SERVICE BULLETIN 35

SUBJECT: CORRECT CONTROL STICK SLEEVE FOR THE GLASAIR II AIRCRAFT

APPLICATION: GLASAIR II KITS SHIPPED WITH A P/N 475-10195-01 CONTROL SLEEVE

FIGURE (1)

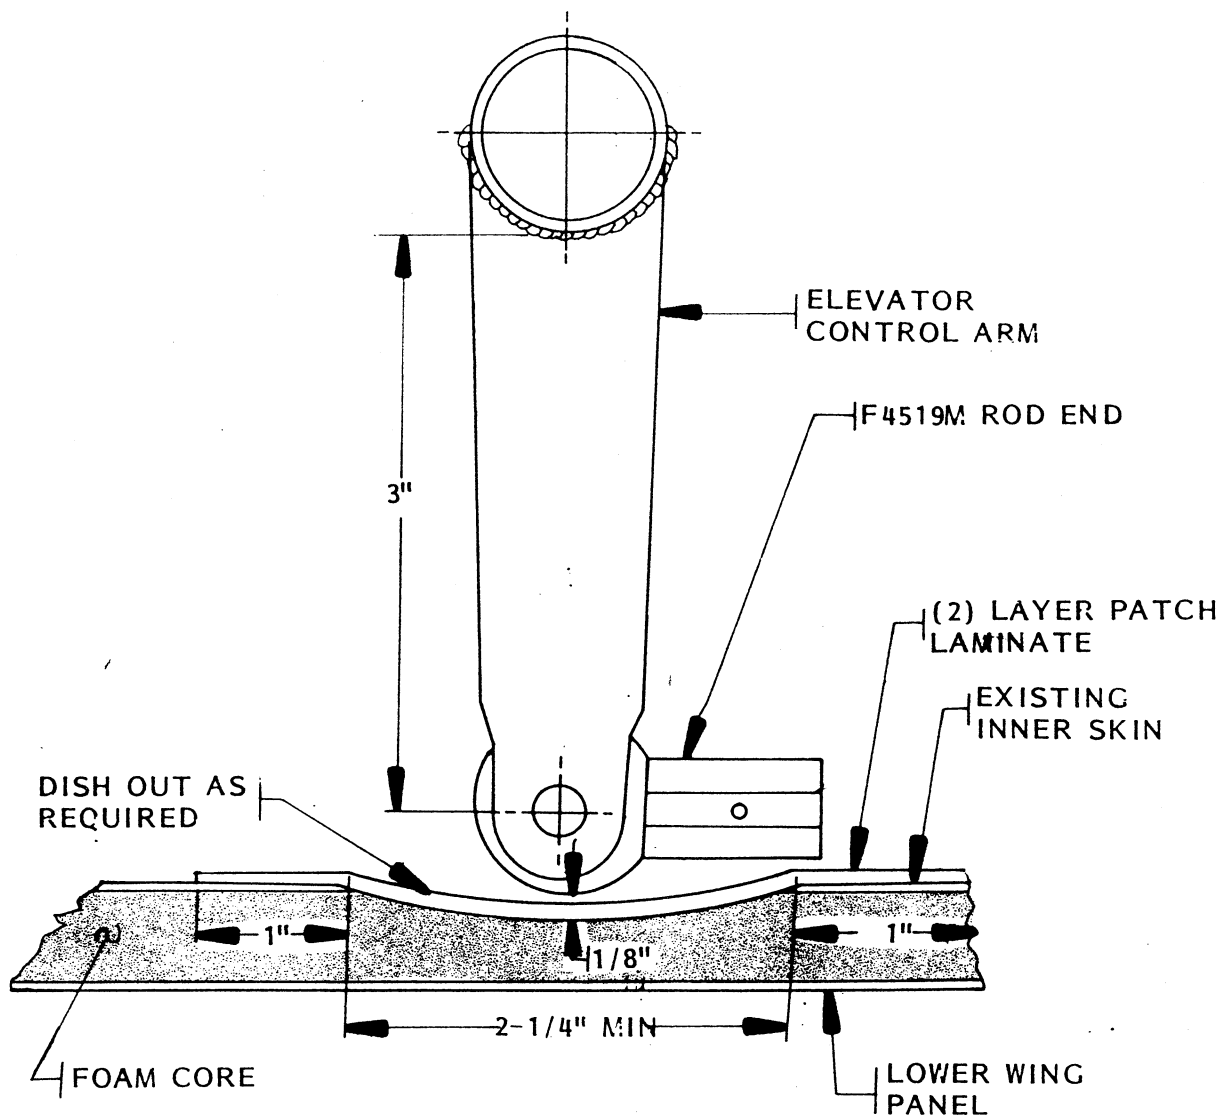
DESCRIPTION: All Glasair II kits shipped prior to 7/16/87 were delivered with the incorrect aileron control sleeve (P/N 475-10195-01). The correct aileron control sleeve for all Glasair II models is P/N 475-3G-3220-01. This control sleeve (P/N 475-3G-3220-01) has a longer actuating arm than the incorrect control sleeve (P/N 475-10195-01).

If you have any doubt as to which control sleeve tube was sent to you, the part number of the control sleeve can be determined by measuring the distance between the outside surface of the control sleeve tube to the center of the bolt hole in the control sleeve actuating arm, as shown in FIGURE (1).

P/N 475-3G-3220-01 _____ 3"
P/N 475-10195-01 _____ 2-1/2"

SOLUTION: If you have recieved the incorrect control sleeve (P/N 475-10195-01), return the incorrect control sleeve to the Shipping Dept. at Stoddard-Hamilton aircraft and the correct P/N control sleeve will be sent to you.

NOTE: With the longer actuating arm, some relieving of the lower wing panel foam core may be required to provide clearance for the elevator control rod end when it is installed on the elevator control arm. Dish the inside laminates and the foam core of the lower wing panel out as required to provide a minimum of 1/8" clearance between the elevator control rod end installed on the elevator control arm and the lower wing panel. Seal the foam of the dished out area with a thin Q-cell resin mixture. Replace the removed laminates by installing a (2) layer bidirectional cloth patch, cut on a 45° bias, over the affected area. The (2) layer patch must be of sufficient size to fill the dished out area and also extend 1" past the modified area, onto the surrounding area.
